Genesis Waste Management Facility, Eastern Creek, Modification 6

Response to Submissions

Prepared for Dial-A-Dump (EC) Pty Ltd
November 2019

J17117 RTS1

Figure A.2 Dust deposition contours for Mod6

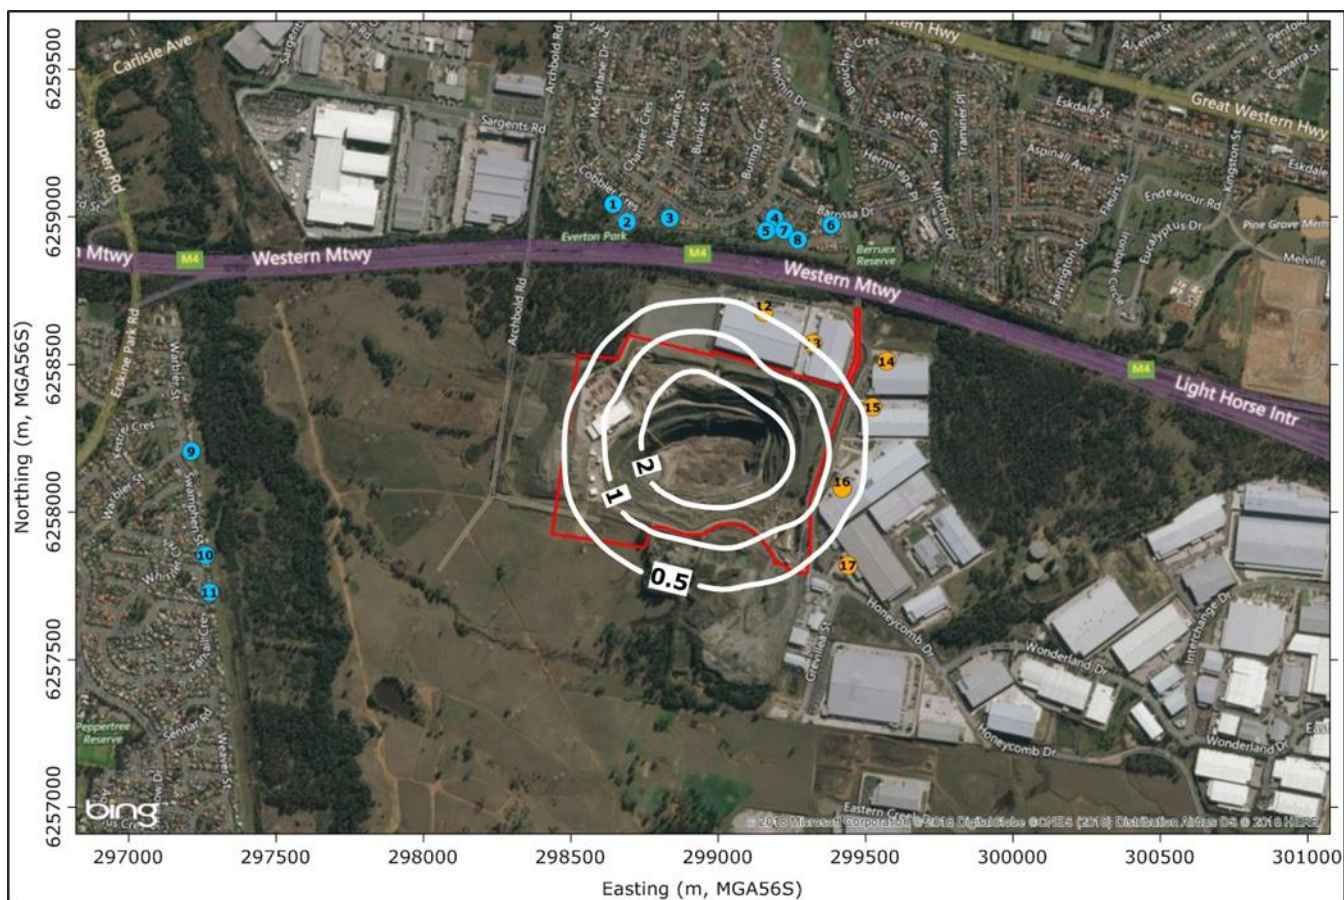
Clarity be sort on the predicted dust deposition impacts noting the difference between tabulated deposited dust predictions and the isopleth in Appendix C.	The TSP contour was inadvertently included in the place holder for dust deposition. The correct dust deposition contour is shown in Appendix A of this report (Figure A-2).	7.3
	<i>Lighting</i>		
	The EPA is concerned that lights used in internal and external operations areas during the proposed increased operational hours will negatively impact nearby receivers, in particular, those approximately 370m to the north and 1.1km to the west of the facility. The Applicant was requested to demonstrate that lighting levels in all operational areas at the facility will meet the requirements of the relevant EPA guidelines. The facility is elevated to the surrounding environment and surrounded by 10m berms. The lighting requirements for internal traffic in the MPC and the landfill will impact nearby residential receivers both directly and indirectly. The lighting	As noted in Table 7.15 of the Modification 6 Environmental Assessment, and acknowledged by DPIE, the lighting at the facility is mostly concealed from far-field views by the berms that surround the site from the former quarry operation. It is noted that the recycling facility already currently operates until 10:00pm at night and has associated lighting, but that there is a considerable distance from the MPC to the nearest residential receptors. An important consideration is the type of lighting used in outdoor settings at the facility. Contrary to the assumption that lighting would need to reproduce 'daylight' conditions for outdoor operations such as landfilling, the optimal arrangement is to have low intensity lighting which provides sufficient illumination to operate safely, and no more. Internal lighting will be 'daylight' level but this is within an enclosed setting. The issue with high intensity night time lighting outdoors is that it can create glare or shine directly into the eyes of operators and drivers, and the preference is for a more even spread of low light rather than pockets of high intensity light and relative darkness elsewhere. It takes a human eye approximately five minutes to fully adjust between bright daylight and darkness.	7.6

<u>Dust deposition rate contour plot:</u> The dust deposition rate contour plot, Figure A5-6 of the AQA, appears to be identical to Figure A5-5 of the AQA (predictions of TSP). The results in Figure A5-6 do not correspond to the tabulated results in the AQA. Therefore, it is likely that Figure A5-6 of the AQA is incorrect and is not representative of the potential impact of the project.	RtS page 41: The TSP contour was inadvertently included in the place holder for dust deposition. The correct dust deposition contour is shown in Figure A-2 of Appendix A to this report.	The RtS is adequate.
